TABLE OF CHANGES FOR PLANNING AMENDMENTS

Project Title
UNION, ST. JOHNS

Drawing Title
NORTH ELEVATION

Drawing Number
6548-P-B500-E-N

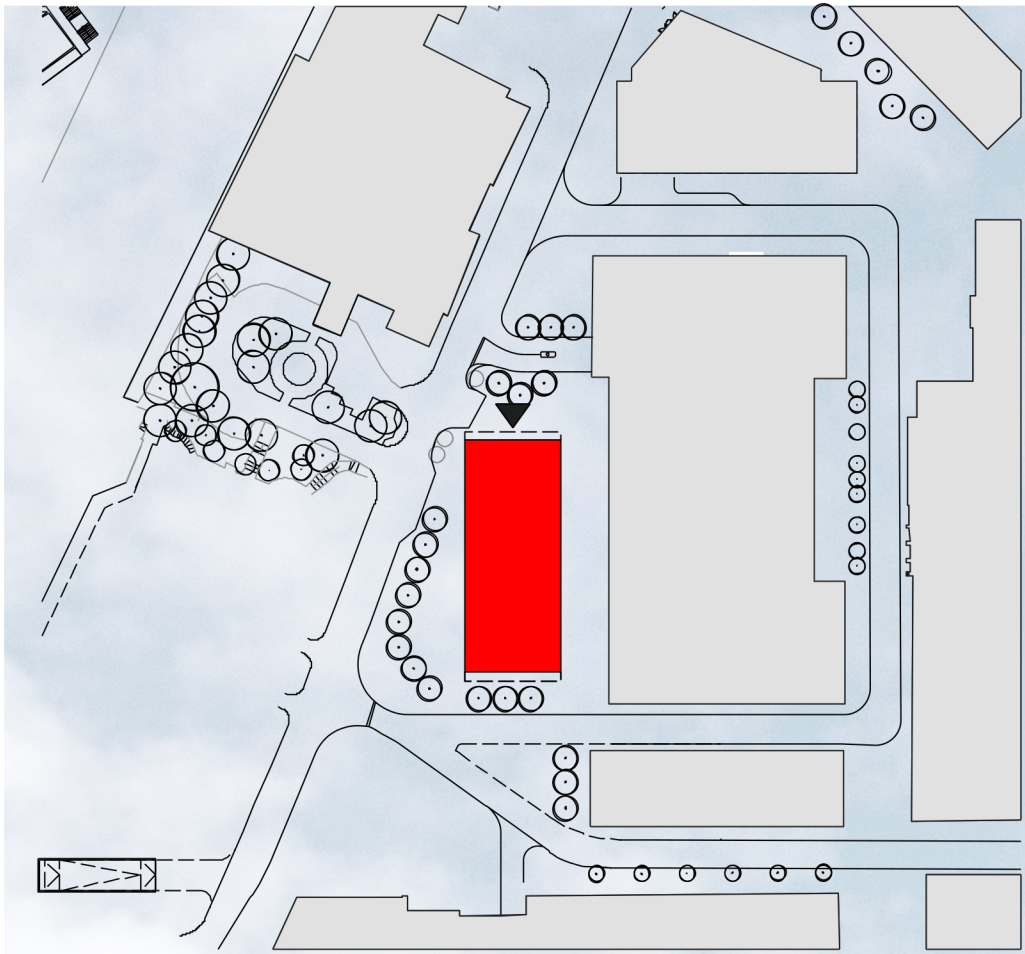
- 1 - EXTERNAL DOORS SIZE/ FORMAT OF EXTERNAL DOORS AT GROUND FLOOR AMENDED
- 2 - FLOOR EDGE SPANDREL PANELS AMENDED SPANDREL PANELS AT LEVEL 01 FLOOR EDGE CHANGED FROM BLACK BACK-PAINTED GLASS TO BLACK INSULATED OPAQUE ALUMINIUM

- 3 - LEVEL 01 SPANDREL PANEL MATERIAL AMENDED SPANDREL PANELS TO WINDOWS AT LEVEL 01 CHANGED FROM BLACK BACK-PAINTED GLASS TO BLACK TINTED GLASS
- 4 - HEIGHT OF EXTERNAL DOORS AMENDED HEIGHT OF EXTERNAL DOORS (TO EAST ELEVATION ONLY) REDUCED BY 200mm

- 5 - LEVEL 01 SPANDREL PANEL MATERIAL AMENDED SPANDREL PANELS TO WINDOWS INTO AMENITY WC AREA (TO EAST ELEVATION ONLY) CHANGED FROM BLACK BACK-PAINTED GLASS TO INSULATED OPAQUE ALUMINIUM

- 6 - NEW FACADE MOUNTED CLOCK NEW EXTERNAL CLOCK MOUNTED AT LEVEL 01 TO WEST ELEVATION ONLY
- 7 - CURTAIN WALLING PANELS AMENDED CURTAIN WALLING GLAZING PANELS SUBDIVIDED TO SMALLER UNITS

- 8 - POST ROOM HATCH OMITTED OPENING HATCH/WINDOW TO POSTROOM ON GROUND FLOOR EAST ELEVATION OMITTED
- 9 - CURTAIN WALLING PANELS RELOCATED CURTAIN WALLING PANELS RELOCATED ON LEVEL 01 IN CONNECTION WITH INTERNAL REORGANISATION OF LEVEL 01 AMENITY SPACE
